DOMINION ENERGY KEWAUNEE, INC.
KEWAUNEE POWER STATION
LICENSE AMENDMENT REQUEST - 217
REVISION TO REACTOR TRIP PERMISSIVE SETPOINTS

**LICENSE AMENDMENT REQUEST - 217
REVISION TO REACTOR TRIP PERMISSIVE SETPOINTS**

**Kewaunee Power Station License Amendment Request 217,
Revision to Reactor Trip Permissive Setpoints**

Figure 1
Kewaunee Power Station
Permissives

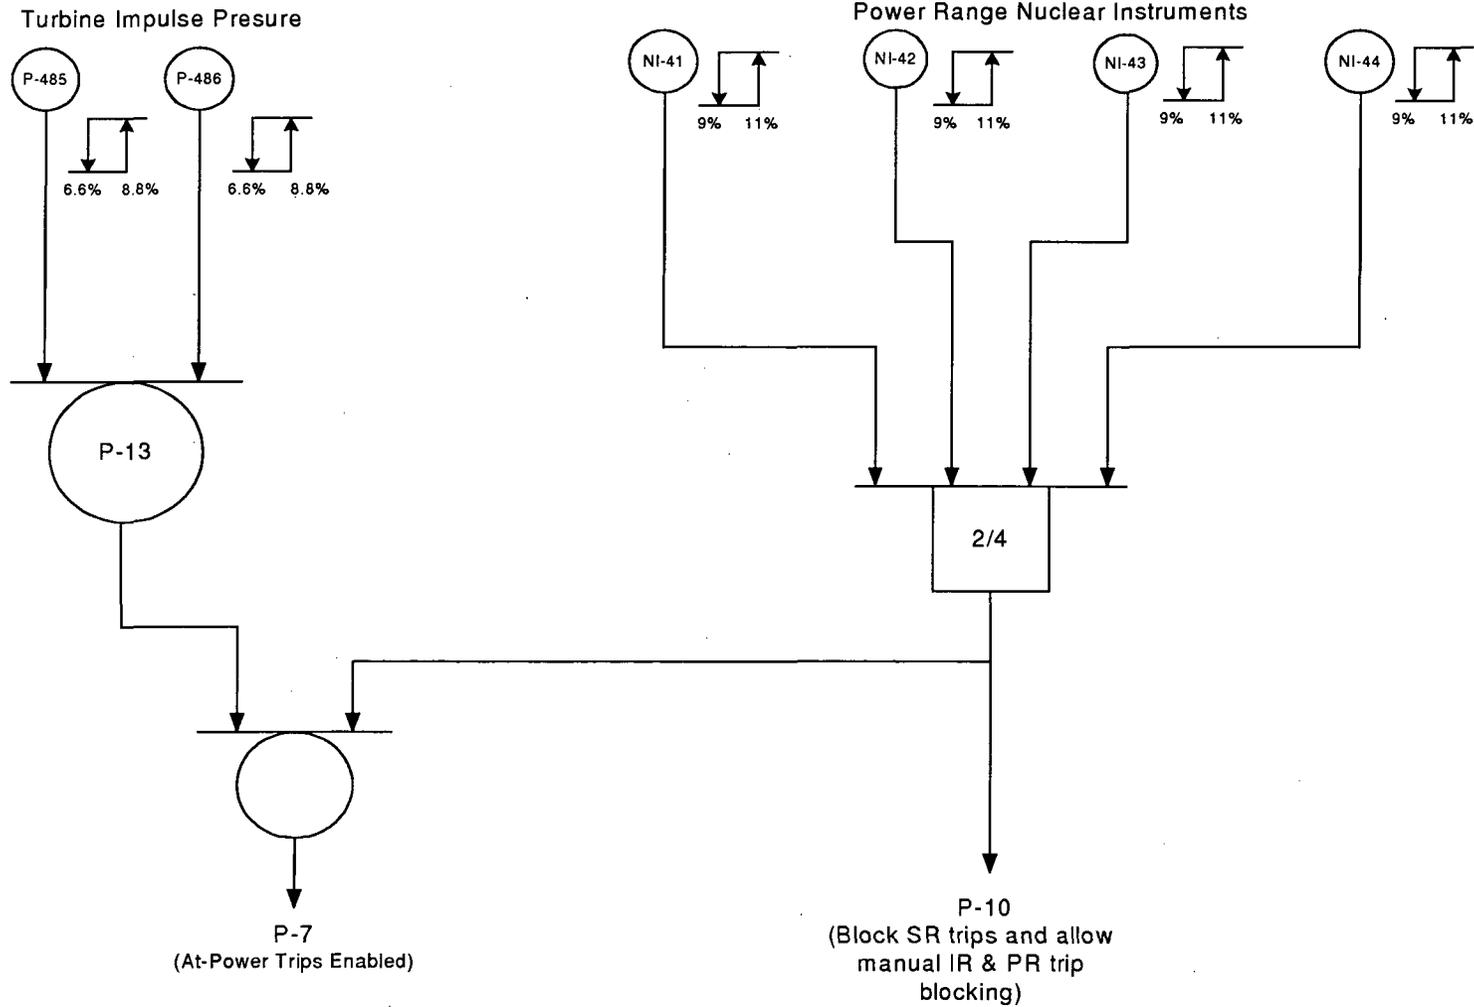
A logic drawing for permissives P-10 and P-7 is shown in Figure 1. Permissive P-10 and P-7 use the same logic relays but operate through different logic matrices and permissive relays. The difference between the P-10 and P-7 circuits is that the permissive relays for permissive P-10 de-energize to allow blocking the intermediate range and certain power range reactor trips while the P-7 permissive relays de-energize to enable the at-power reactor trips.

Using the setpoints listed in Figure 1, when two-of-four Power Range NI channels are greater than 11% power, a signal is sent to the P-10 and the P-7 permissives. This signal allows manual blocking of the IR NI channels High Flux reactor trip, manual blocking of the PR High Flux Low Setpoint reactor trip, and automatically enables the at-power trips. When two-of-four energized logic is not true (i.e., at least three-of-four NI channels less than 9% power) the signal is removed from P-10 and P-7, and unblocks the associated PR and IR channels reactor trips and automatically blocks the at-power trips, provided turbine impulse pressure is less than 6.6% power.

The four NI channels provide an input to the P-10 relay. As reactor power is increased to above 11%, the P-10 relay provides an output (when two of the four NI channels exceed the relay setpoint) to permit manual blocking of the IR High Flux and PR High Flux Low Setpoint reactor trips and an input to the P-7 relay, which enables the trips listed in TS 2.3.a.6.A. Note that the P-7 relay may already be activated if a turbine impulse pressure switch exceeds its setpoint before the NI channel bistables exceed their setpoint. Therefore, before exceeding 12.2% rated power, the at-power reactor trips are unblocked and manual blocking of the IR High Flux and PR High Flux Low Setpoint reactor trips is permitted.

On decreasing reactor power, when three-of-four P-10 relays reset (less than 9.0% rated power) the P-10 permissive is no longer satisfied and the IR High Flux and PR High Flux Low Setpoint reactor trips are unblocked while the trips blocked by P-7 are automatically blocked, provided the turbine impulse pressure circuit indicates impulse pressure is less than its reset point.

Because both the P-7 and P-10 circuits use the same logic relays, the settings for permissive P-10 and P-7 cannot be identical since one permissive operates from the set function of the logic relays while the other operates from the reset function of the logic relays. Based on this inherent difference in relay operation, a setpoint band is needed to allow proper setting of the permissives while maintaining the nominal 10% reactor power setpoint used since initial plant start up.

DEK has performed a calculation to determine the P-10 and P-7 setpoint uncertainties. The proposed change to TS Table 3.5-2 permissives P-10 and P-7 equates to a high setting limit of 12.2% with a low setting limit of 7.8%. The calculation results show that the loop drift of the NI instrumentation is +/- 0.67%. After adjusting the setting limits for instrumentation loop drift and using 2% for the relay set to reset difference (the actual plant setting for the relays to close is at 11% and open at 9%) a margin of 0.53% remains between the setting limits and the actual plant setpoints. Figure 2 shows the proposed setpoints, uncertainties, and margins for the P-10 and P-7 relays.

The proposed new setting limits for the permissives are specified in Table TS 3.5-2. The relay set and reset functions must occur within the range of the "setting limits" as specified in Table 3.5-2, for acceptable plant operation.

Figure 2
Setpoint Uncertainties

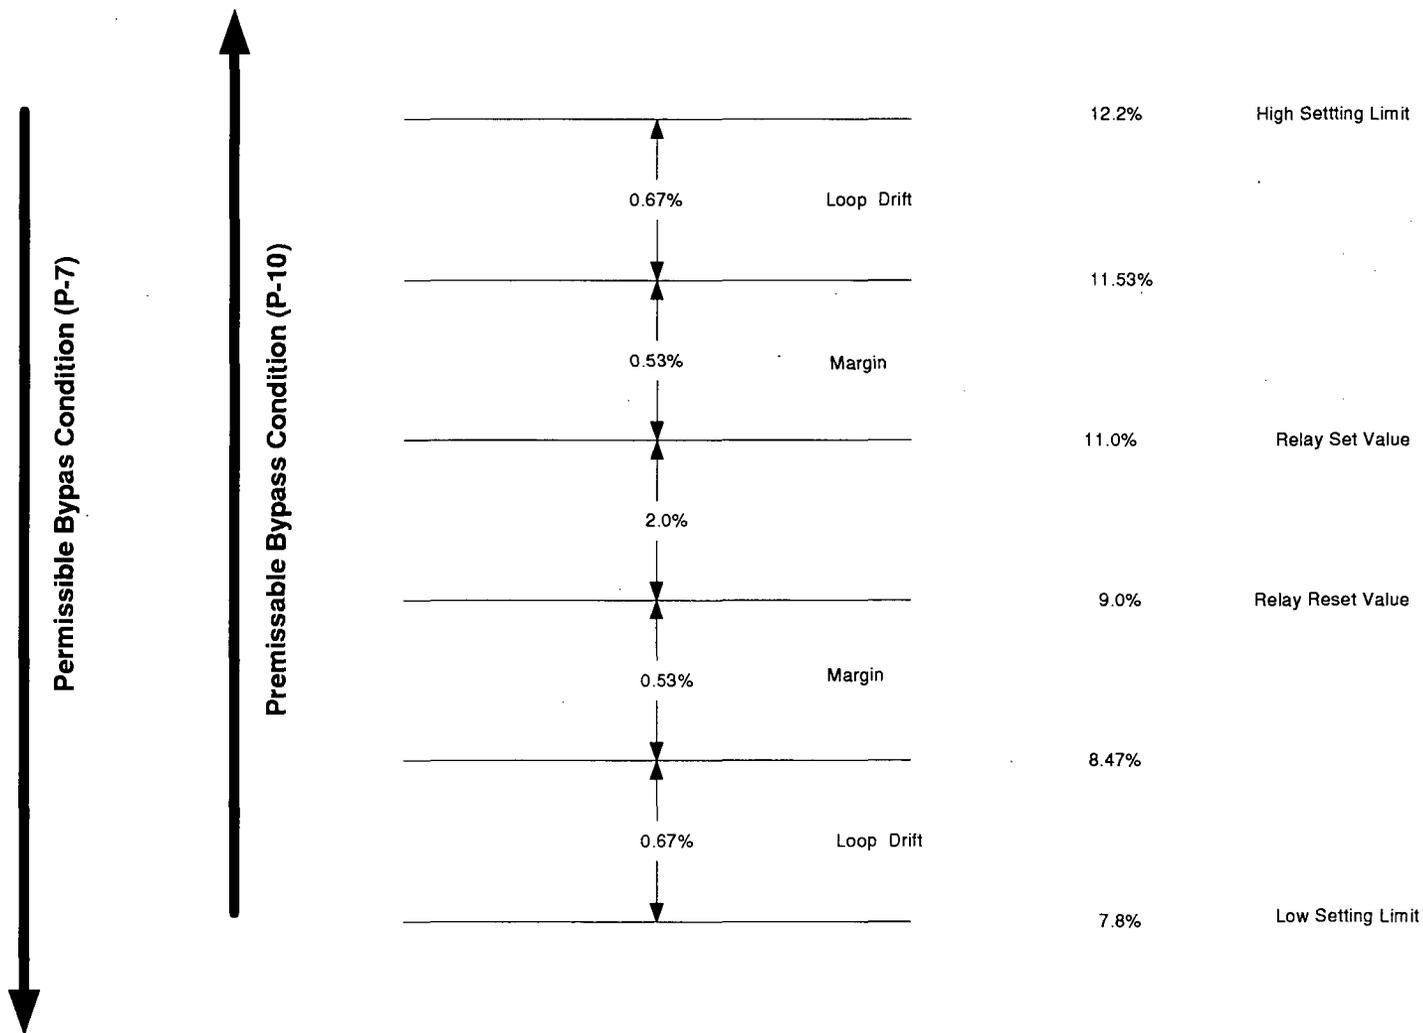
Additionally, the above STS excerpt contains a “Reviewer’s Note” stating that some units TS may only contain an allowable value. This proposed change is similar in nature to that statement. The similarity is that Kewaunee CTS currently contain what could be considered the “Nominal Trip Setpoint” (10% reactor power). This proposed change would allow maintaining a nominal trip setpoint of approximately 10% by changing the technical specifications to model the allowable value by adding a band for the setting limit. The permissive P-10 nominal trip setpoint would be bounded by the lower limit of the permissive P-10 value contained in the TS Table 3.5-2 NOTE permissive table for Kewaunee (7.8% reactor power) and bounded by the upper limit of the P-7 power range nuclear instrument value (12.2% reactor power) (refer to Figure 2).
